RECEIVED
 CKB BY CLD OK'D BY GAS
 AUG 03 2007
 RESUBMIT APPROVED AS NOTED
 BY KMH DATE 8/13/07

BRIDGE No 37
 PROJECT No BRF 030-2(17)S
 ITEM No 621.74

FOR: F R LAFAYETTE, INCORPORATED
 VERMONT AGENCY OF TRANSPORTATION
 TOWN OF JOHNSON, COUNTY OF LAMOILLE
 BRIDGE RAILING FOR VT15 (MINOR ARTERIAL) OVER GHON RIVER
 3L ALUMINUM APPROACH ~ SPLICE DETAILS

MADE CMS DATE 05/29/07 JOB No AR0395 CUST No
 CHECK BLJ DATE 06/01/07 DRAWING LB15 REV. No. ONE

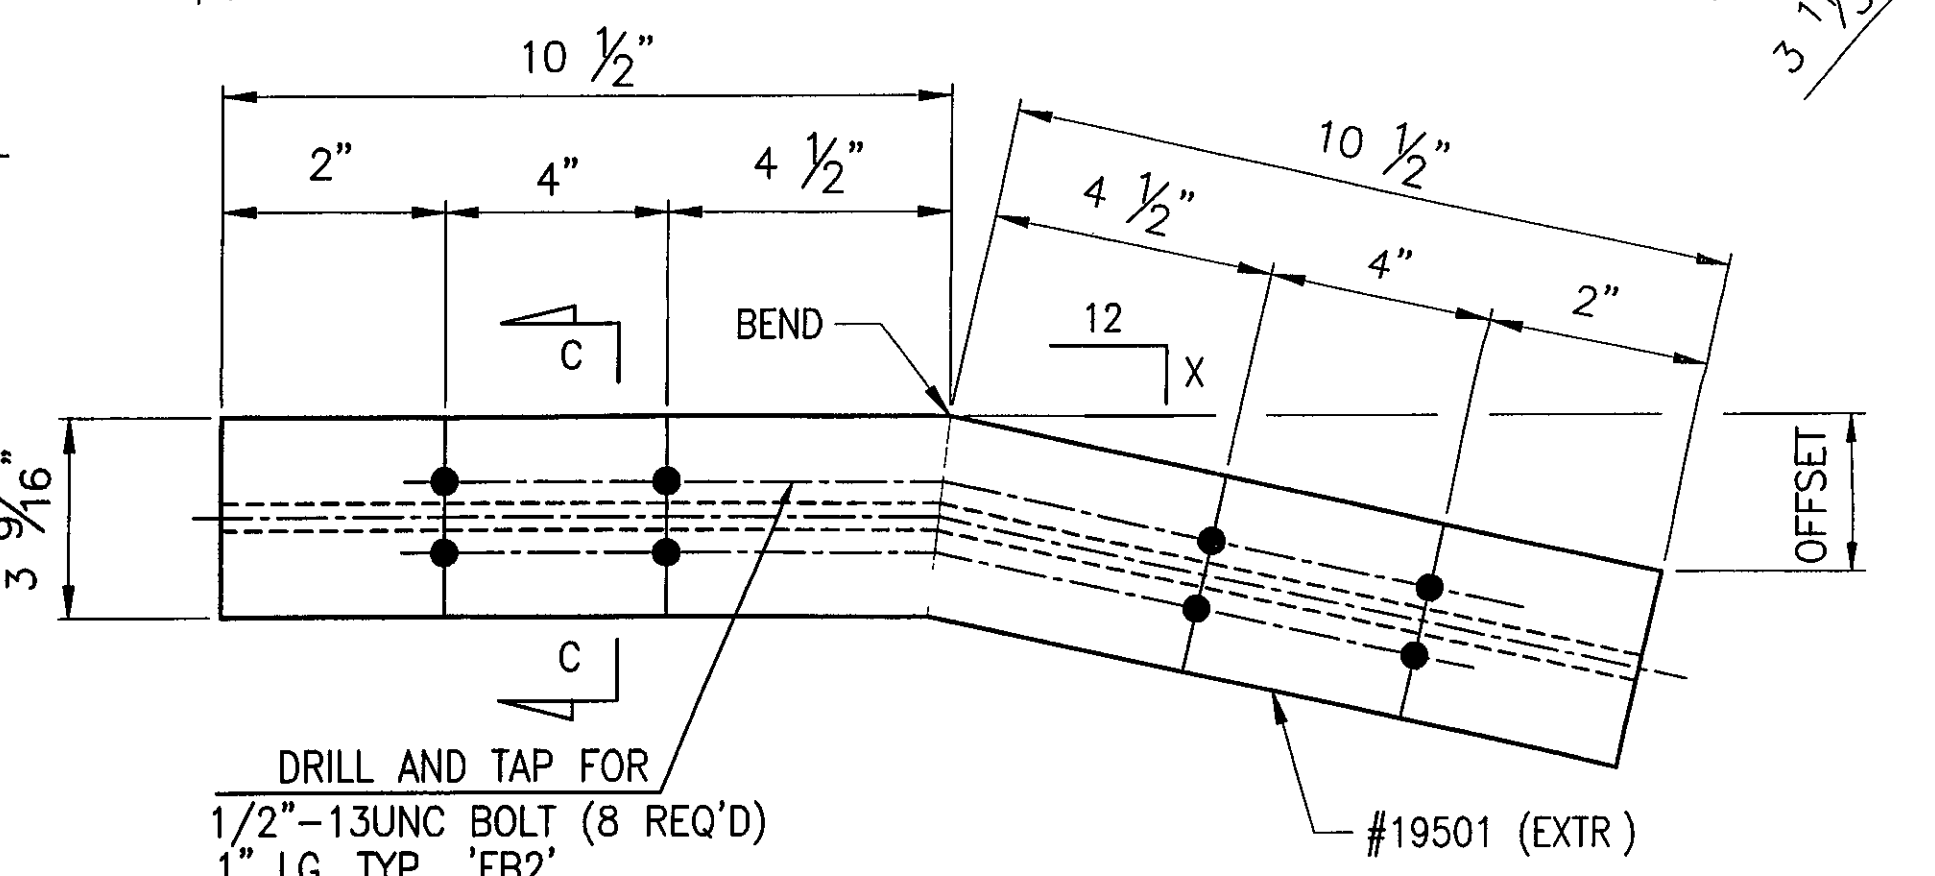
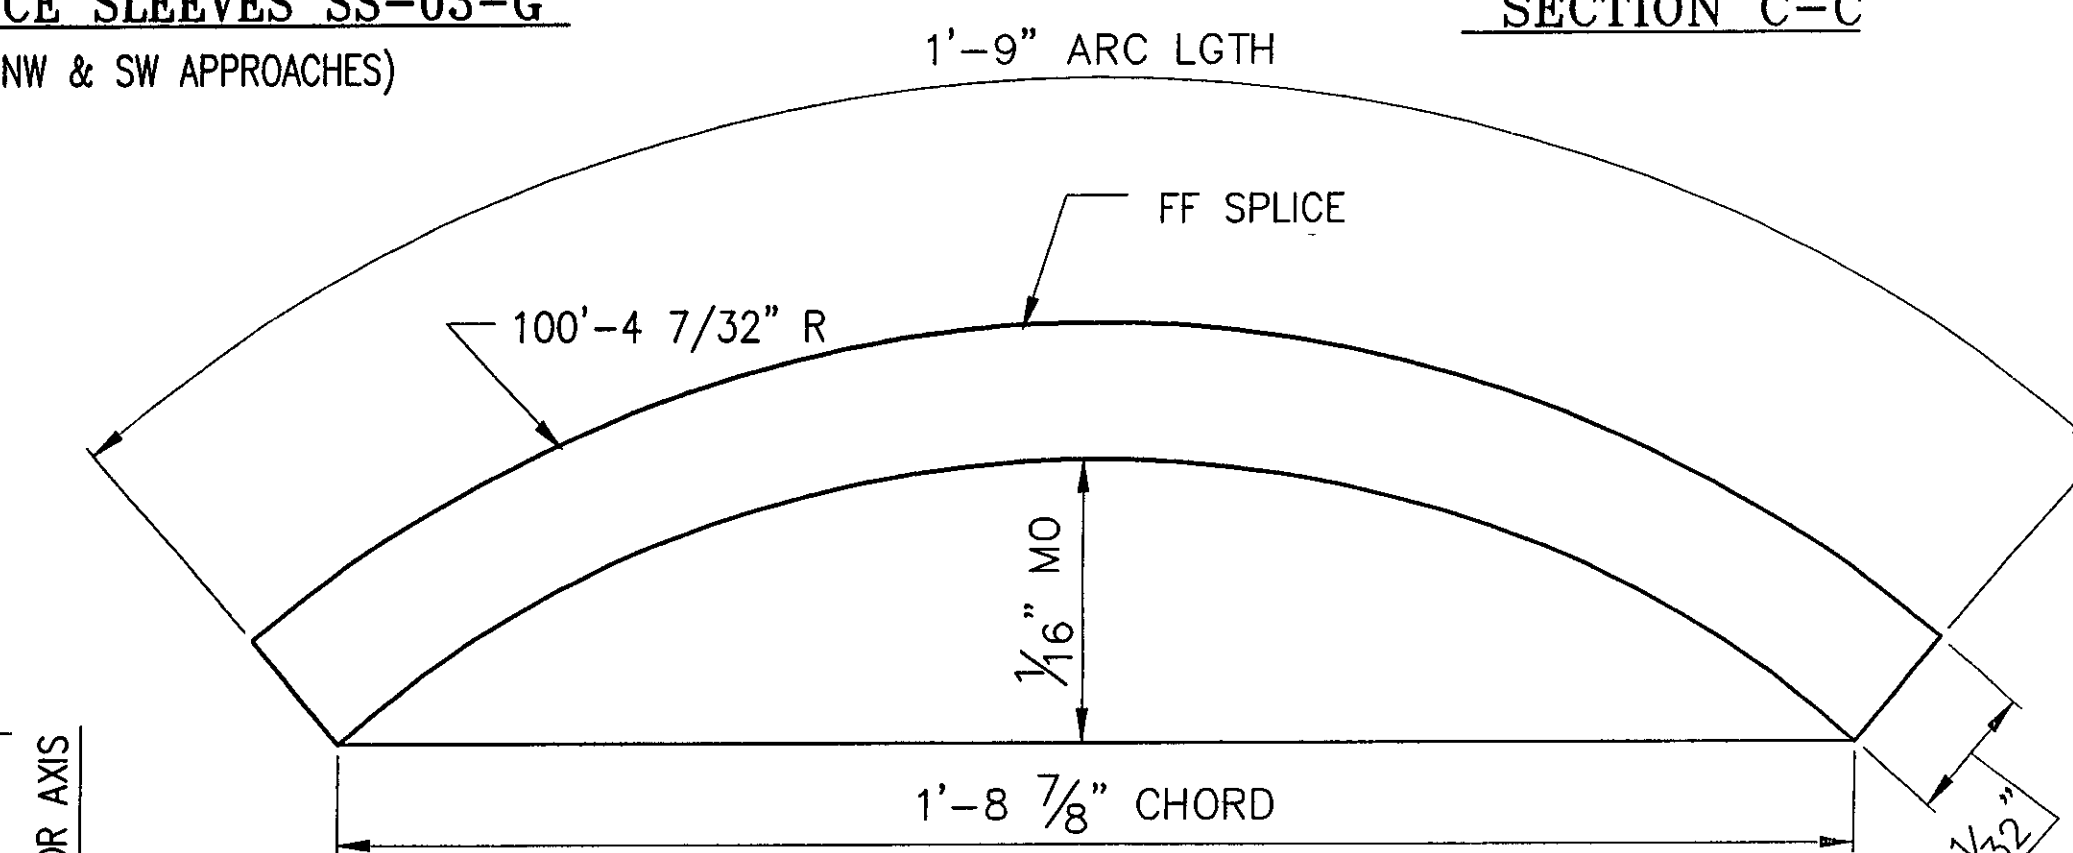
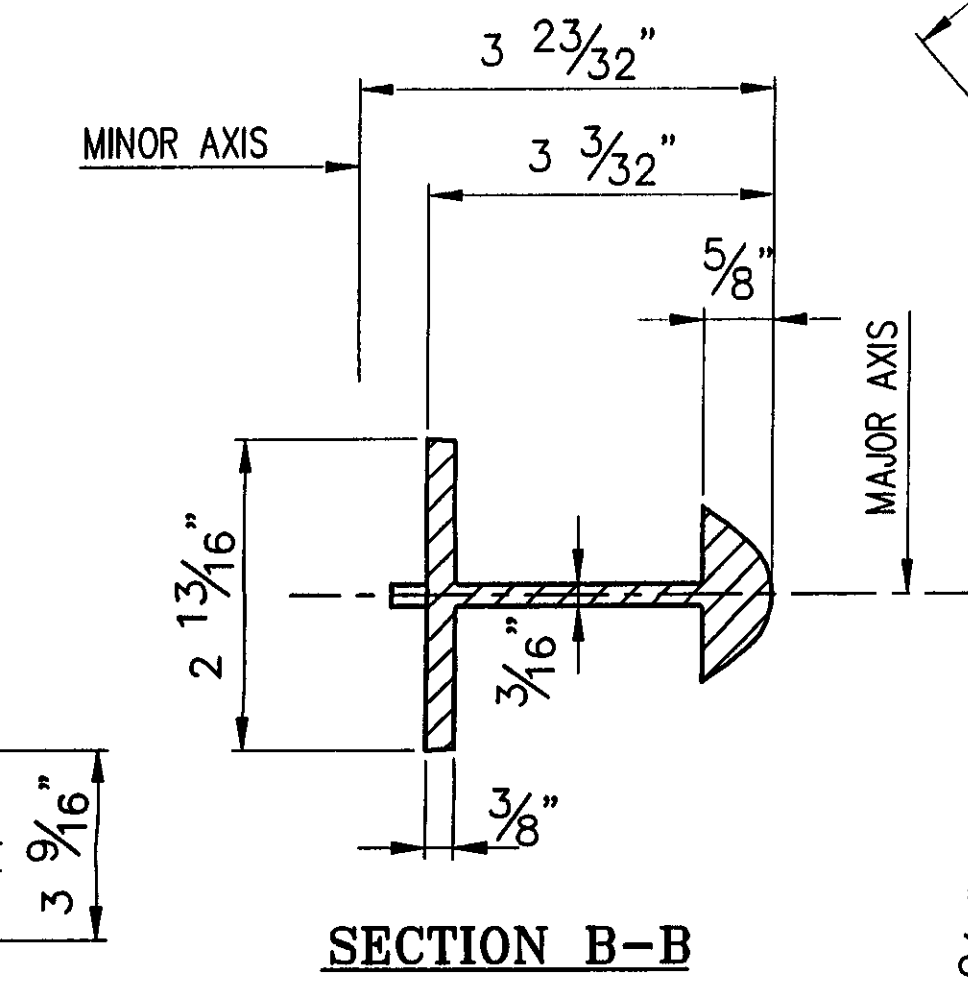
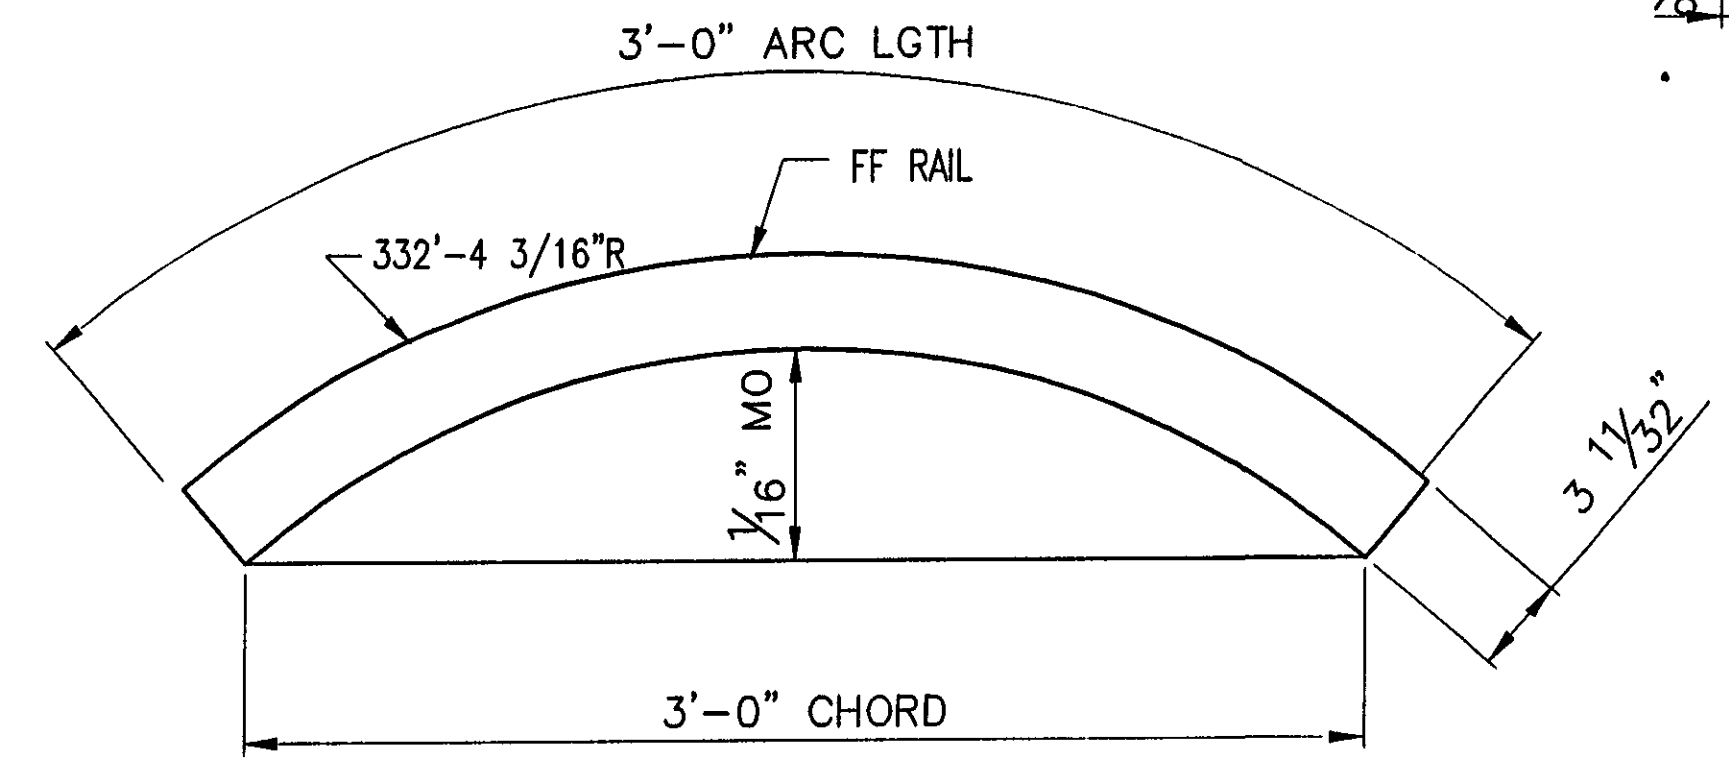
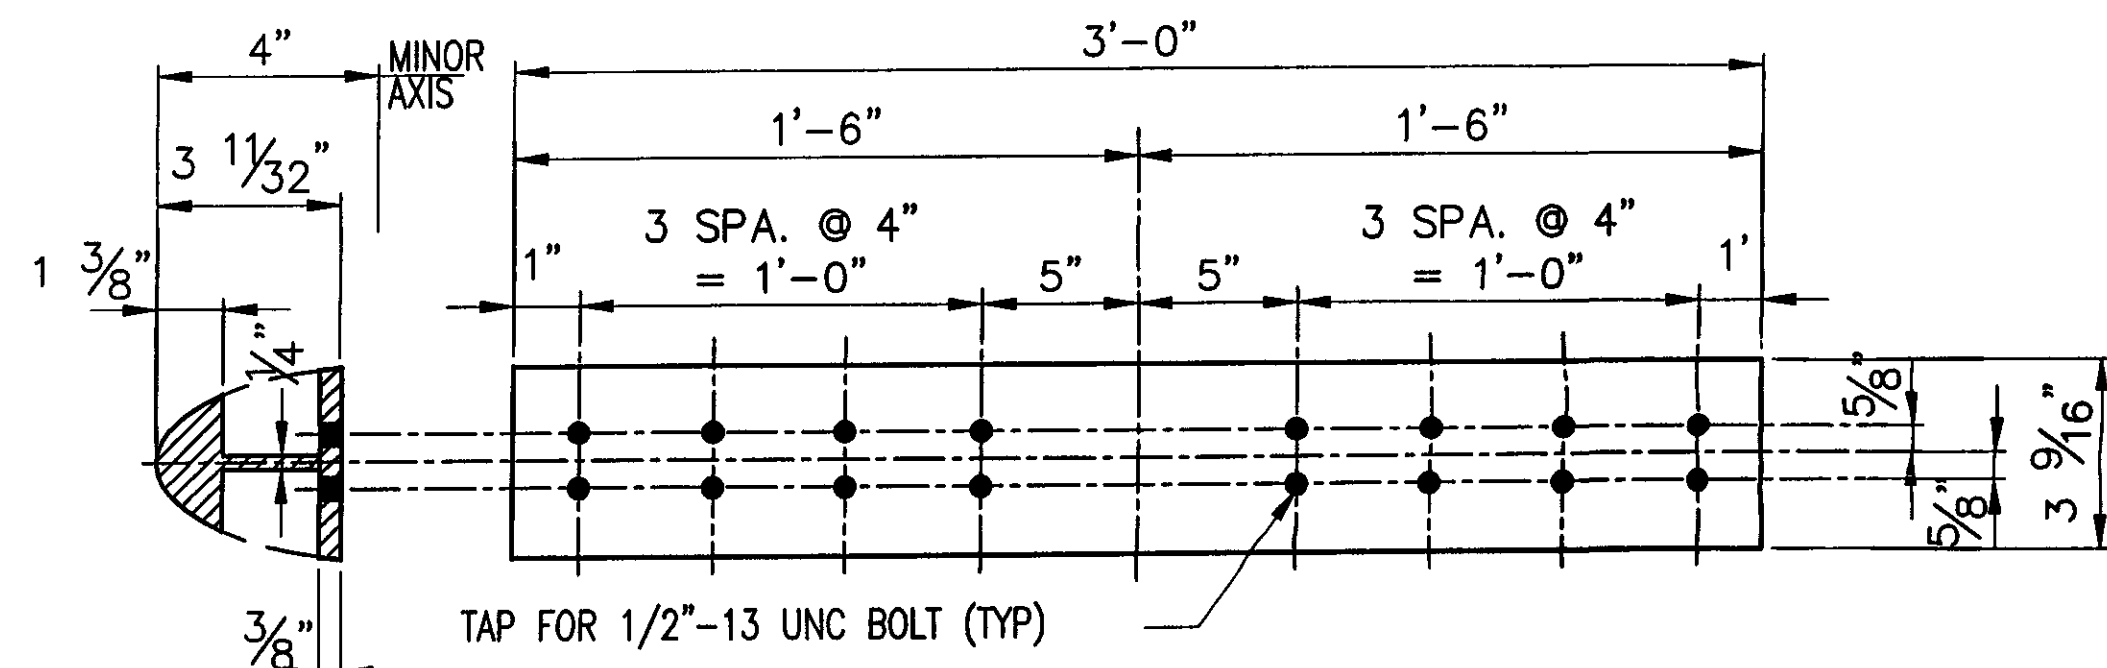
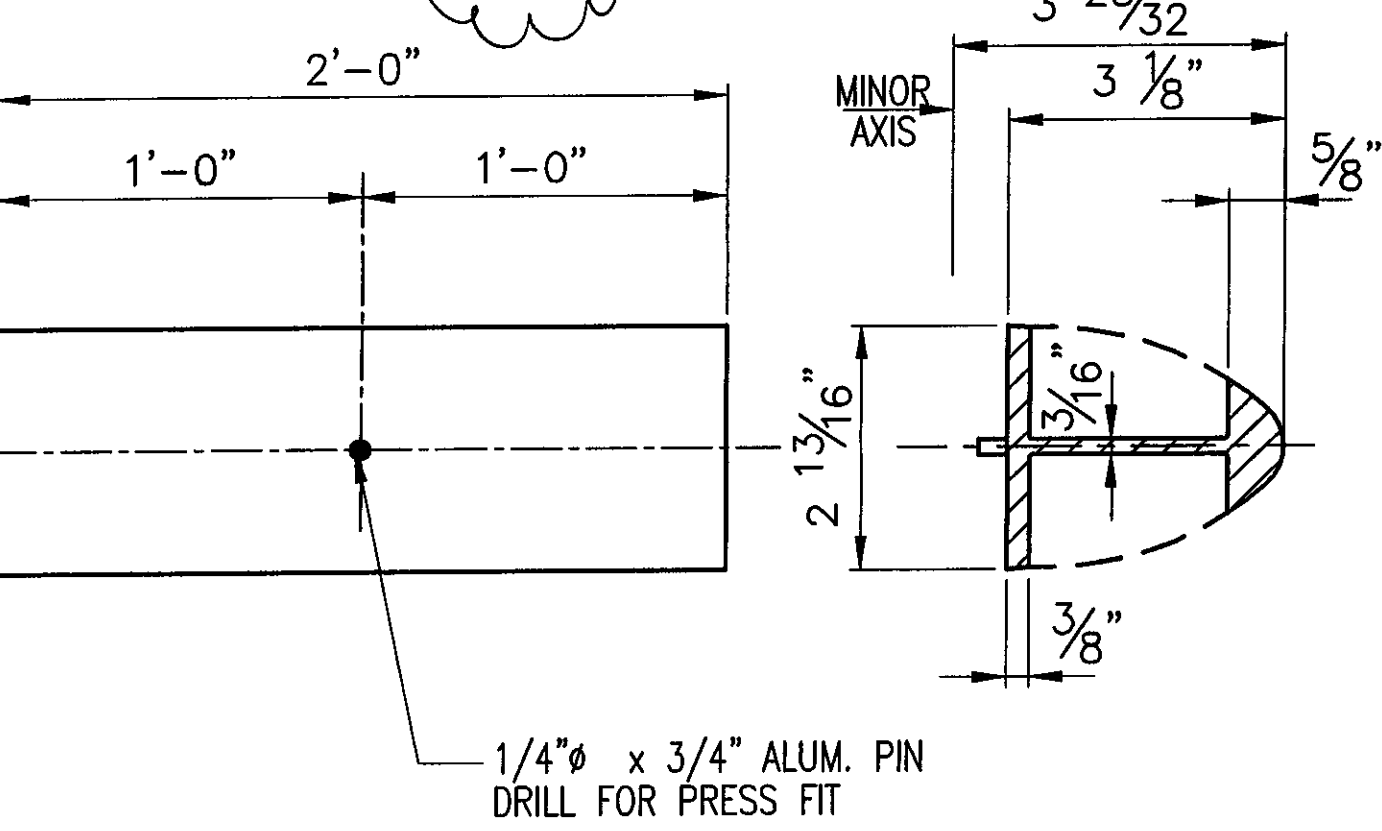
REV	DESCRIPTION	BY	DATE
1	REVISED DIMENSIONS PER APPROVERS MARKUPS	CMS	07/24/07
